Access Compliance Report

Public Rights-of-Way

(Curb Ramps)

Intersection ID: 6323	Main Street: AMHERST_GLEN_DR	Cross Street: BILLINGS_PARK_DR	Location:	N
ADA ID: 176AE8122A6F	Ramp Type: Perp	Initial Pass/Fail: Fail	Overall Compliance: No	Severity Score: 22.5
Codes/Mitigation Info/Possible Solution		Field Measurements/Component Compliance

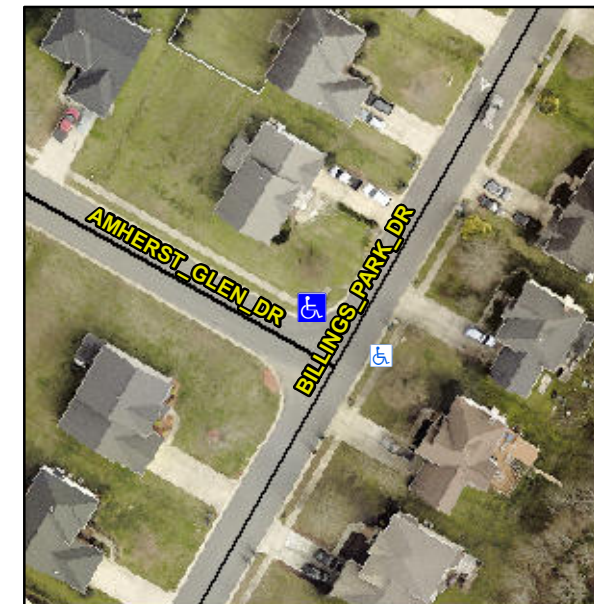
Not Found, R304.5.1, R304.2.2, R304.5.3

Compliance	Description	Data	Compliance	Description	Data
N/A	Ramp Length (in)	48.0	No	Ramp Slope (%)	11.3
No	Ramp Width (in)	44.0	No	Ramp XSlope (%)	3.6
N/A	Flare Type LT	N/A	N/A	Flare Type RT	N/A
N/A	Flare Slope LT (%)	N/A	N/A	Flare Slope RT (%)	N/A
N/A	Flare Traversable LT?	N/A	N/A	Flare Traversable RT?	N/A
N/A	Landing Length (in)	N/A	N/A	DWS Provided?	N/A
N/A	Landing Width (in)	N/A	N/A	DWS Contrast?	N/A
N/A	Landing Slope (%)	N/A	N/A	DWS Length (in)	N/A
N/A	Landing X Slope (%)	N/A	N/A	DWS Full Width?	N/A
N/A	Landing Curb? (Y/N)	N/A	N/A	DWS Offset (in)	N/A
N/A	Shared Landing?	N/A			
N/A	Gutter Ponding?	N/A	N/A	Gutter Slope (%)	N/A
N/A	Gutter Lip Ht (in)	N/A	N/A	Gutter X Slope (%)	N/A
N/A	Painted X Walk1?	No	N/A	Painted X Walk2?	N/A
	X Walk 1 Direction	To SE		X Walk 2 Direction	N/A
N/A	X Walk 1 Width (in)	N/A	N/A	X Walk 2 Width (in)	N/A
	X Walk 1 Slope (%)	3.2		X Walk 2 Slope (%)	N/A
	X Walk 1 X Slope (%)	1.0		X Walk 2 X Slope (%)	N/A

Remove & Replace Entire Ramp.
